Umstellung Spannsätze E-Servo Schneckengetriebe

Adjustment of Shrink-Discs for E-Servo Worm Gear Units

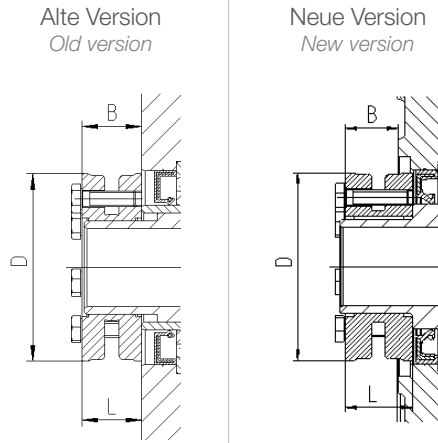
E-Servo a=50	
Schrumpfscheibe <i>Shrink-Disc</i>		80 83 130	80 83 030
D	[mm]	60	60
L	[mm]	18	21,5
B	[mm]	(mind./min.) 18	(mind./min.) 16,7
		E-Servo a=63	
Schrumpfscheibe <i>Shrink-Disc</i>		80 84 136	80 84 036
D	[mm]	72	72
L	[mm]	21,5	23,5
B	[mm]	(mind./min.) 19	(mind./min.) 16,1
		E-Servo a=80	
Schrumpfscheibe <i>Shrink-Disc</i>		80 85 150	80 85 050
D	[mm]	90	90
L	[mm]	24	27,5
B	[mm]	(mind./min.) 24,5	(mind./min.) 19,5
